Ref: L260519 Lighting Review with Regards to Bats – 2029 Horton Road, Devizes, Wiltshire

Lighting Review: Bats and Hazel Dormice (Lighting Plan Revision 2)

Appendix 1: Proposed Lighting Layout at Ground Level

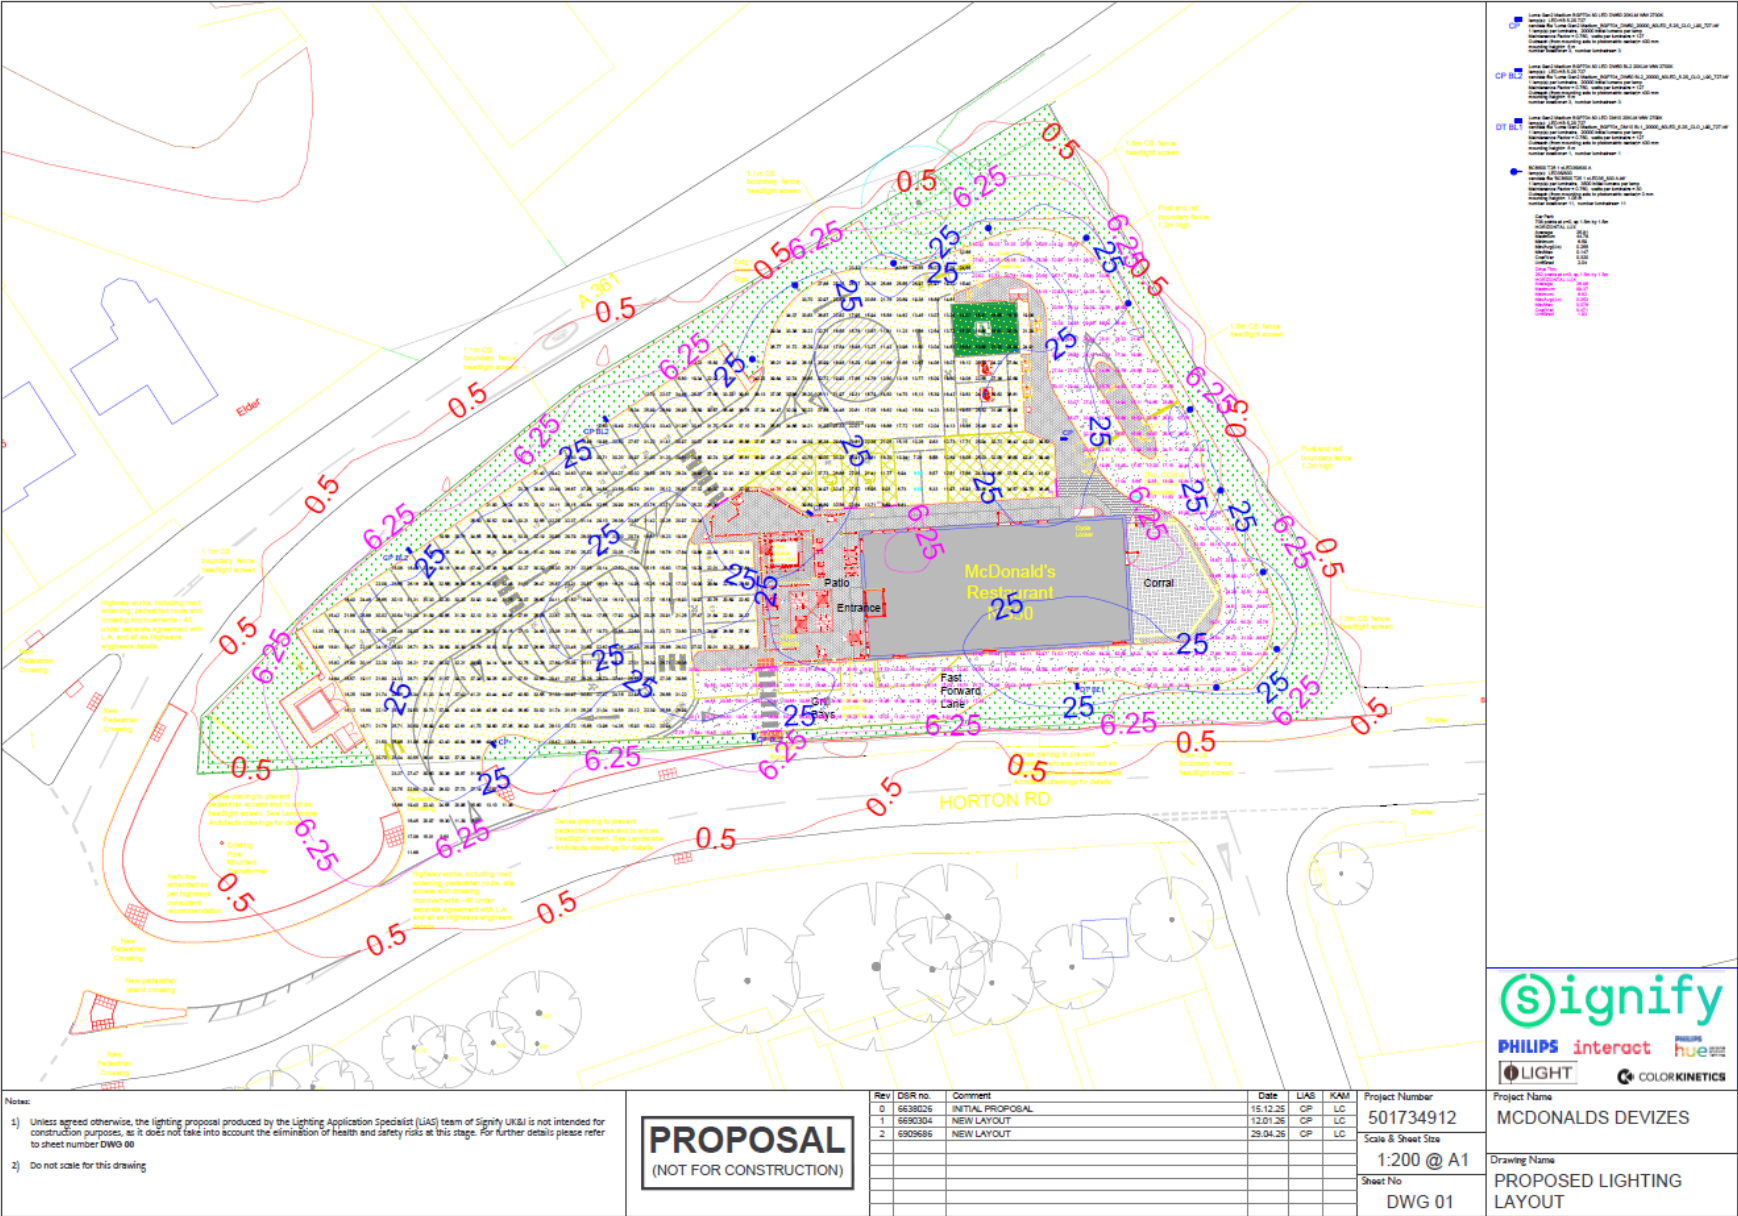
The types proposed include six Luma Gen2 Medium BGP704 80 LED DW50 20KLM WW 2700K, which will be mounted approximately 6 m above ground level and provide 20000 initial lumens per lamp, three of these

luminaries with have a backlight louvre fitted to prevent backwards lightspill. One Luma Gen2 Medium BGP704 80 LED DM10 BL1 20KLM WW 2700K, which will be mounted approximately 6 m above ground level and provide 8000 initial lumens per lamp and will have a backlight louvre fitted. Eleven OptiSpace BCB500 T25 1 xLED35/830 A, which will be mounted approximately 1.05 m above ground level and provide 3500 initial lumens per lamp. All of the aforementioned lighting is set at zero degrees, therefore there will not be any upward or horizontal light at 6 metres. Additionally, the lighting will be 2700k warm white, have an Ra greater than 60, and have wavelengths greater than 550nm.

The majority of the Optispace bollards are located along the eastern boundary to illuminate the drive through lane, and lightspill between 6.25 and 25 lux occurs on proposed mixed scrub planting. As such, the bollards are only 1.05 m in height and the proposed close board fencing along the drive-thru, this will protect the eastern boundary corridor (mixed scrub) and the retained trees from the lightspill, as well as lightspill from cars using the drive-thru.

The area of the proposed mixed scrub along the northern boundary will be subject to light spill between 6.25 and 25 lux from the Optispace and Luma Gen2 lighting, as well as light spill from parked cars. However, it has been noted this area is currently regularly managed modified grassland and is subject to significant lightspill from the existing buildings onsite, roadside lighting and adjacent residential development and motorbike training centre which does not provide suitable foraging habitat for bats and hazel dormice.

No light spill is anticipated on habitats adjacent to the Site with foraging and commuting suitability and it is noted that the Site is already subject to significant lightspill.

In conclusion, the lighting scheme in its current form alongside the implementation of the close board fencing is acceptable as no impacts on bats and hazel dormice are anticipated due to no light spill occurring on areas which are likely to be used by roosting, foraging, and commuting bats and nesting, foraging and commuting hazel dormice as a result of an increase in external artificial light spill from the scheme.
